Technical Service BULLETIN

IMPROVEMENT TO REAR WIPER WASHER NOZZLE

'00 – '01 RAV4

BODY
B0004-02

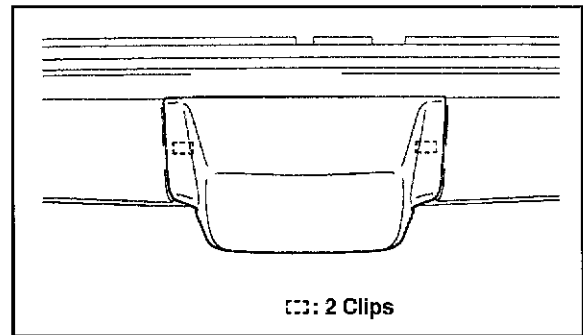
Introduction The rear wiper washer nozzle has been changed from a one-hole type to a two-hole type for improved washing performance.

1. Remove the interior Center High Mounted Stop Lamp (CHMSL) cover using a nylon pry-tool or a flat head screwdriver protected with tape.

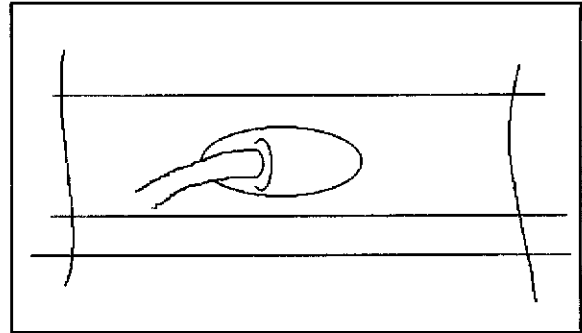
2. Remove the grommet surrounding the washer tube as it enters the rear door.

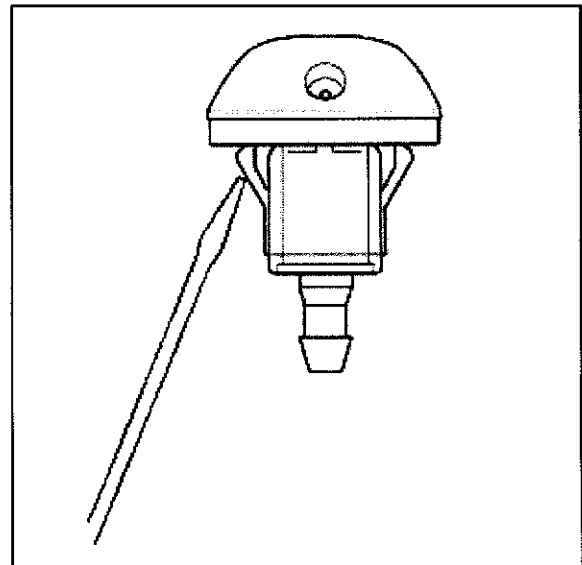
3. Remove the original washer nozzle by depressing the lock tabs with a screwdriver.

4. Reassemble with the new washer nozzle.
